CHURCHILL DOWNS SUBDIVISION, 2ND UNIT,
RESUBDIVISION OF LOTS 105 - 107

APPLICATION NUMBER 19 DATE December 6, 2007

DETAIL SITE PLAN

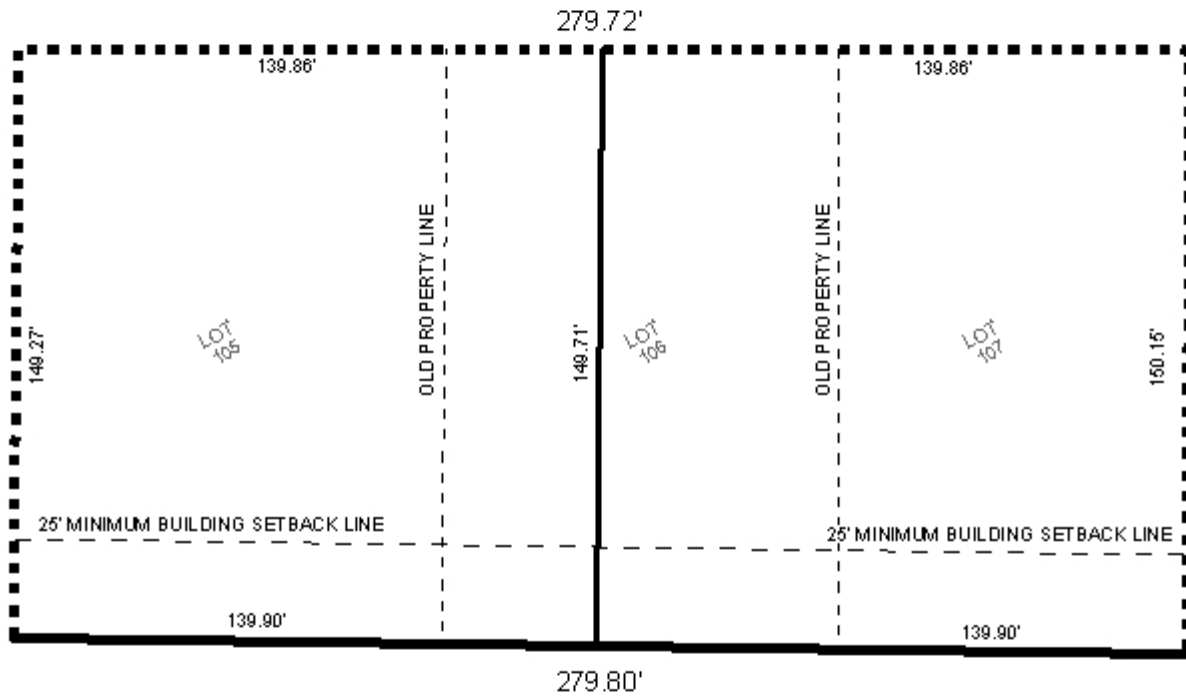
The site fronts Wulff Road which has a current right-of-way width of 80'. Wulff Road is a planned major street, requiring a 100' right-of-way. Therefore, the dedication of sufficient right-of-way to provide 50' from the centerline should be required. Additionally, as a means of access management, a note should be placed on the final plat stating that each lot is limited to one curb cut to Wulff Road, with the size, design and location of the curb cuts to be approved by Mobile County Engineering and conform to AASHTO standards.

The 25' minimum building setback line is indicated on the plat. This should also be shown on the final plat, but adjusted to be measured from any required right-of-way dedication. The plat did not indicate the lot sizes; therefore, the plat should be revised to label each lot with its size in square feet, or a table depicting the same information should be provided.

A note should be required on the final plat stating that any lots which are developed commercially and adjoin residentially developed property must provide a buffer, in compliance with Section V.A.7. of the Subdivision Regulations.

While the site is in Mobile County, it will have to comply with the City of Mobile storm water and flood control ordinances. A note should be placed on the final plat stating that the development will be designed to comply with the storm water detention and drainage facility requirements of the City of Mobile storm water and flood control ordinances, and requiring submission of certification from a licensed engineer certifying that the design complies with the storm water detention and drainage facility requirements of the City of Mobile storm water and flood control ordinances prior to the issuance of any permits. Certification is to be submitted to the Planning Section of Urban Development and County Engineering.

- 1) dedication of sufficient right-of-way to provide 50' from the centerline of Wulff Road;
- 2) placement of a note on the final plat stating that each lot is limited to one curb cut to Wulff Road, with the size, design and location of the curb cuts to be approved by Mobile County Engineering and conform to AASHTO standards;

- 3) depiction of the 25' minimum building setback line on the final plat, as measured from any required right-of-way dedication;
- 4) revision of the plat to label each lot with its size in square feet, or the provision of a table furnishing the same information;

- 5) placement of a note on the final plat stating that any lots which are developed commercially and adjoin residentially developed property must provide a buffer, in compliance with Section V.A.7. of the Subdivision Regulations; and

- 6) placement of a note on the plat stating that the development will be designed to comply with the storm water detention and drainage facility requirements of the City of Mobile storm water and flood control ordinances, and requiring submission of certification from a licensed engineer certifying that the design complies with the storm water detention and drainage facility requirements of the City of Mobile storm water and flood control ordinances prior to the issuance of any permits. Certification is to be submitted to the Planning Section of Urban Development and County Engineering.
